DATE: March 11th, 2026

RE: Addendum No. 1 to the Bidding Documents for:
NPS Gateway National Park Maintenance Building
Schemmer Project No. 009258.012

This addendum consists of two (2) pages of written addendum items and twelve (12) pages of supplemental drawings.

ARCH/ENG PROJ # 09258.012
SUB SHEET NO. **E002**
DRAWING NO. 366 / 80034
PMIS / PKG. NO. **320855**
SHEET **13** OF **16**

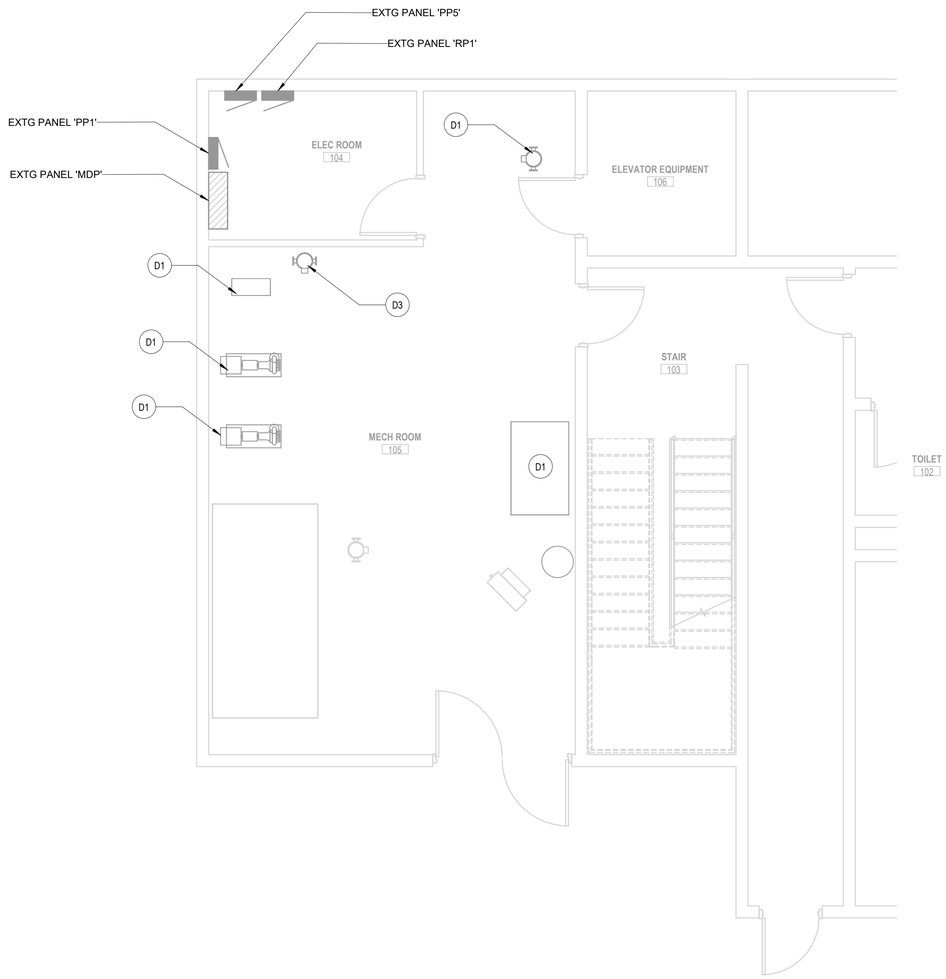
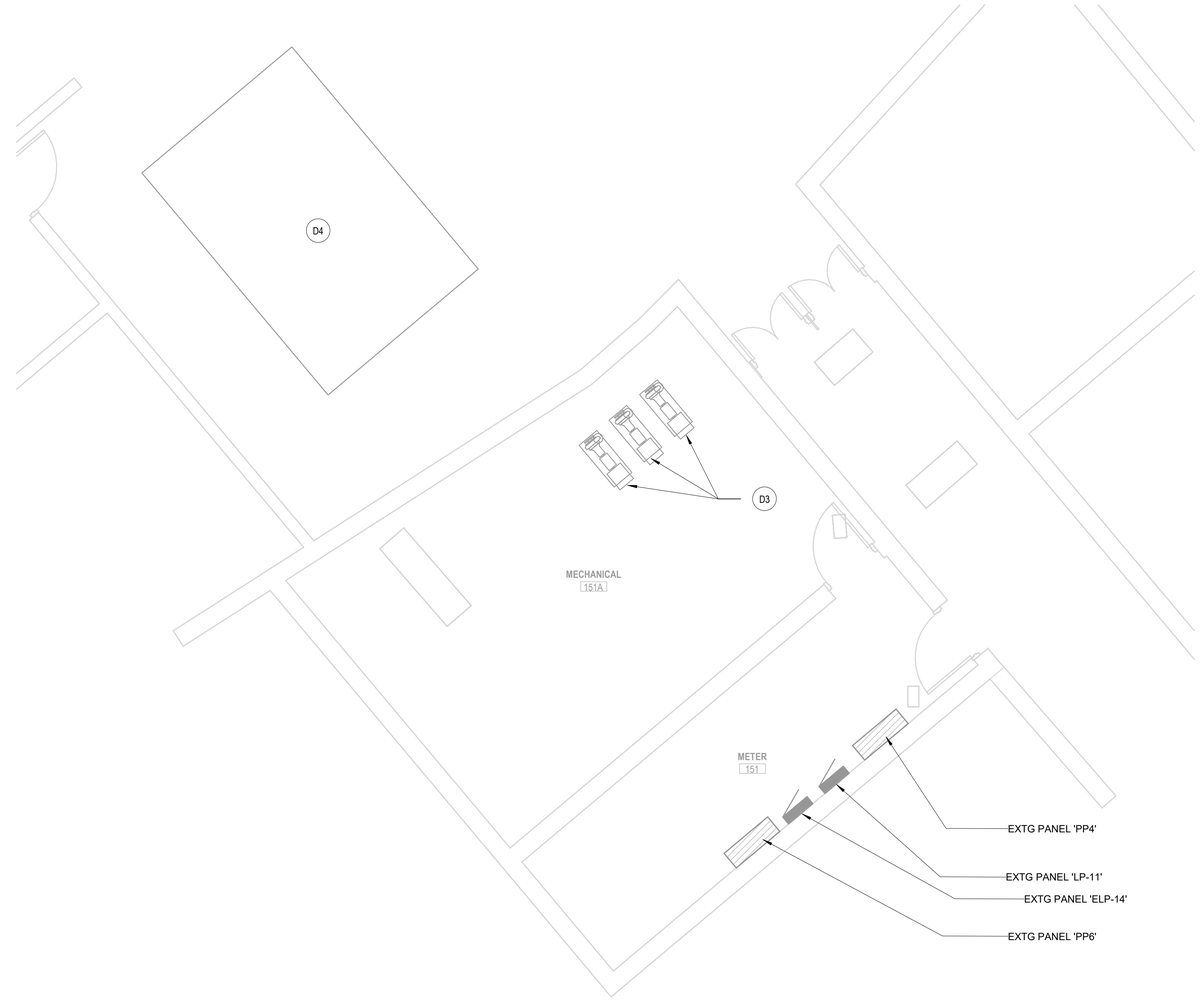
Item No. DE-3, Sheet E002
Changed view titles to include the CLIN associated with the work depicted in the views.

ARCH/ENG PROJ # 09258.012
SUB SHEET NO. **E201**
DRAWING NO. 366 / 80034
PMIS / PKG. NO. **320855**
SHEET **14** OF **16**

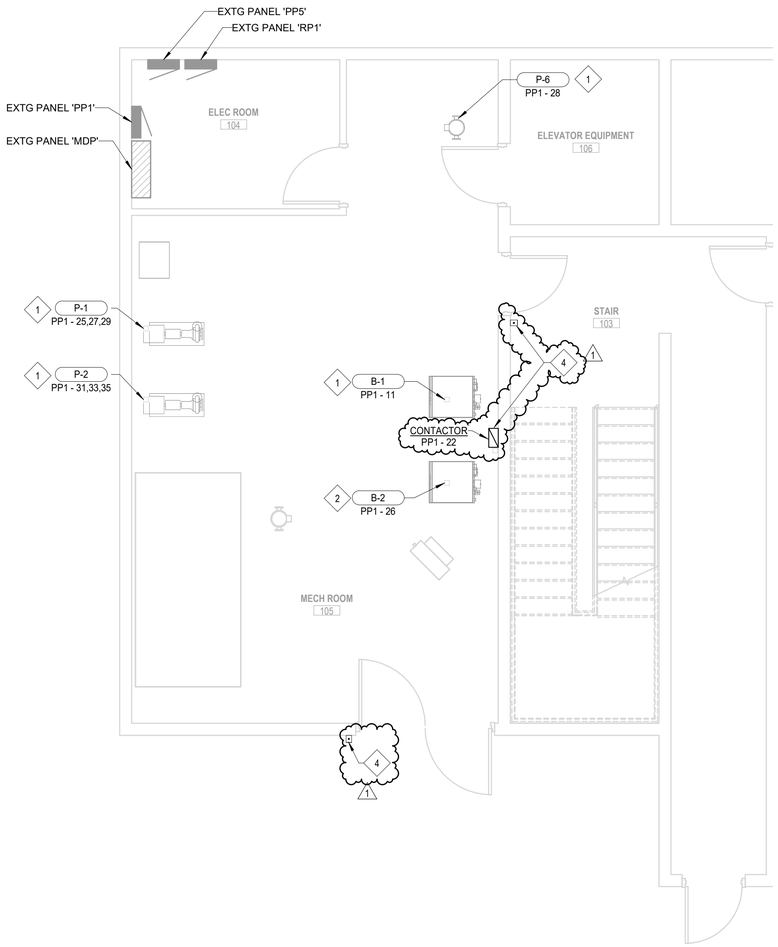
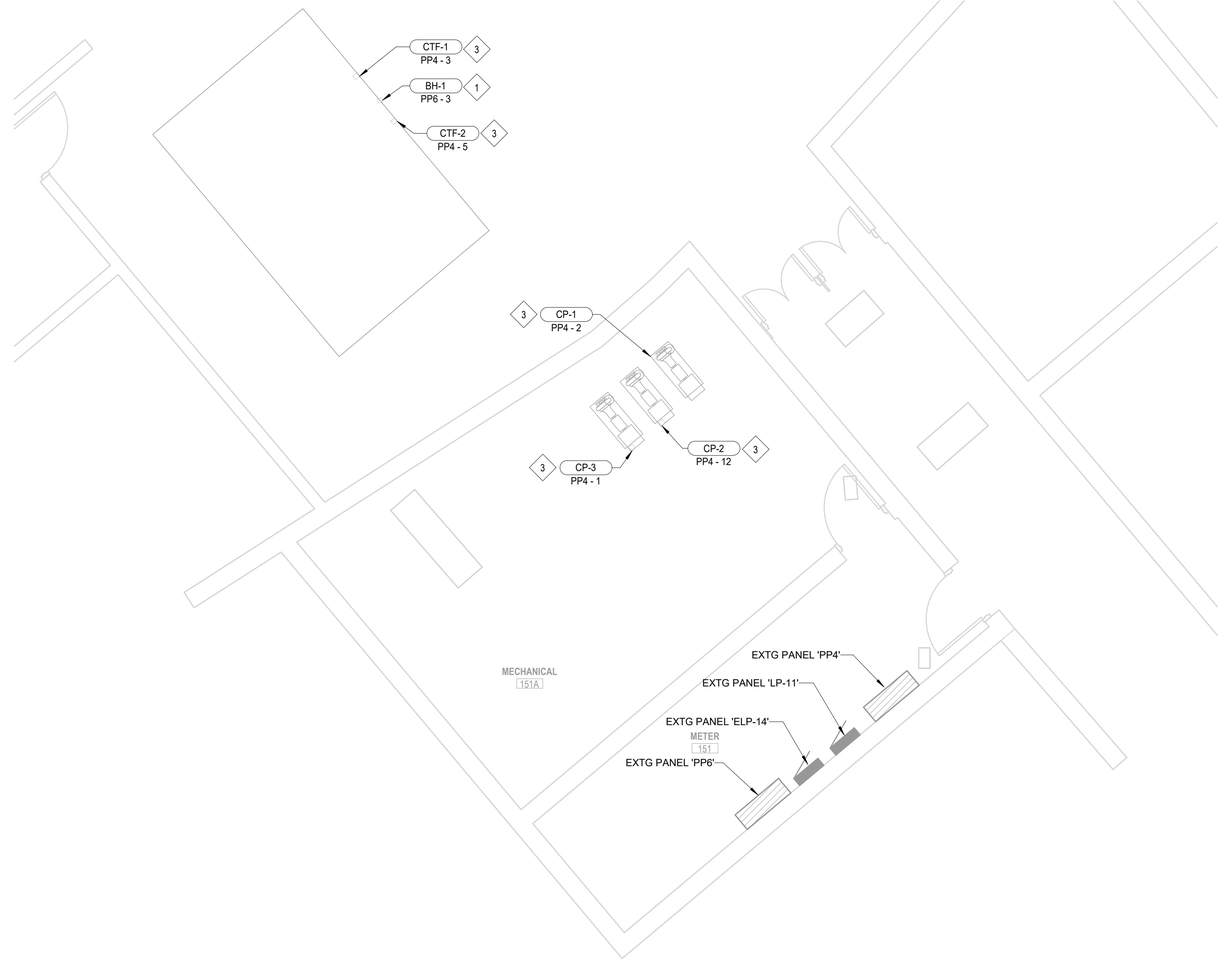
Item No. DE-4, Sheet E201
Changed view titles to include the CLIN associated with the work depicted in the views.
Updated and added referenced notes.

Item No. DE-5, Sheet E201
Added boiler shut-off emergency switches.

1. REUSE EXISTING CONDUIT AND CONDUCTORS TO PREVIOUSLY SERVING EQUIPMENT AT THIS LOCATION, TO EXTENT POSSIBLE. EXTEND CIRCUITING AS REQUIRED FOR NEW EQUIPMENT CONNECTION.
2. CONNECT TO EXISTING CIRCUIT BREAKER MADE SPARE BY DEMOLITION.
3. PROVIDE NEW CIRCUIT BREAKER IN SPACE MADE AVAILABLE BY DEMOLITION TO SERVE NEW EQUIPMENT. PROVIDE NEW BRANCH CIRCUIT WIRING.
4. PROVIDE 4-POLE (2-ACTIVE, 2 SPARE) 120V COIL ELECTRICALLY HELD CONTACTOR FOR CONTROL OF BOILER POWER CIRCUITS. PROVIDE TWO (2) MUSHROOM STYLE, TWIST TO RELEASE PUSH BUTTONS WITH NORMALLY CLOSED CONTACTS. PROVIDE CONDUIT, BOXES, CLEAR BUTTON COVERS AND WIRING AS NECESSARY FOR COMPLETE EMERGENCY SHUTDOWN FOR BOILERS. PROVIDE LABELS FOR BUTTONS TO READ "EMERGENCY BOILER SHUT-OFF".
